MEMORANDUM

SUBJECT: BZA Case 21497: Request for special exception relief to allow construction of a one-story, accessory garage with a roof deck at 222 17th Place N.E.

Figure 1. Surveyor's Plat

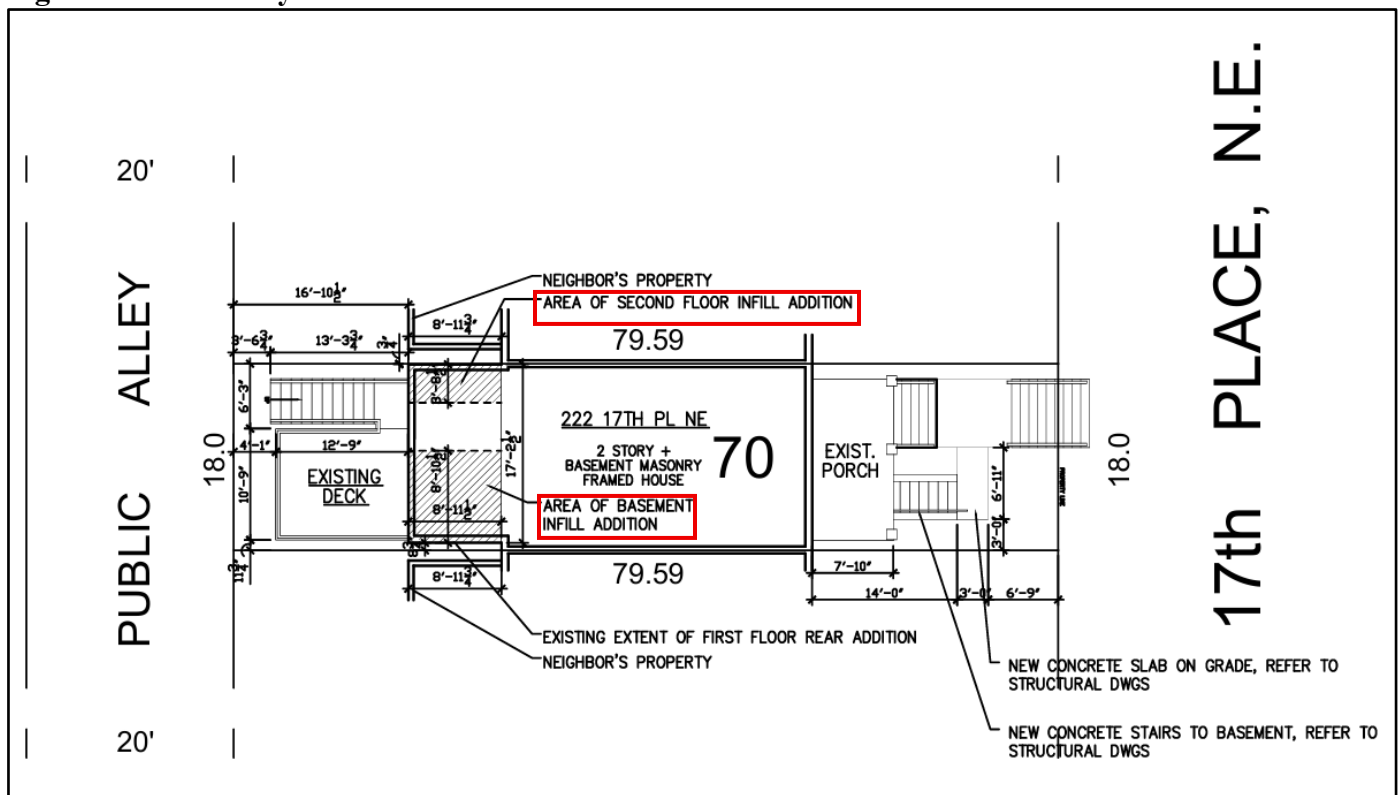
infill a small area at the second story as shown in the DC Surveyor Plat at [Exhibit 7](#), reproduced below for ease of reference. The Applicant is also proposing a basement-level infill addition within the footprint of the existing basement area as shown.

The Applicant also requests rear yard relief as the existing deck is entirely within the non-conforming rear yard. The deck measures 137 square feet. (The area seems to conform to the new Subtitle B § 312.4 which states that uncovered decks to a max of 200 square feet is excluded from the measurement of lot occupancy.) At the writing of this report, the Applicant has not verified OP's comments regarding whether lot occupancy relief is required. Therefore, the relief will be reviewed as the application is self-certified.

The existing rear deck is located within the required rear yard, and therefore the rear yard must be measured to the rear lot line from the farthest extent of the structure pursuant to Subtitle B § 312.4(h). Although the deck does not exceed the maximum 200 square feet permitted for uncovered decks within the required rear yard, its presence within that yard means the proposal cannot rely on the standard rear-yard measurement to the building wall. As a result, the project requires relief from the rear-yard requirement because the existing deck establishes a rear-yard depth that is less than what is required for the zone.
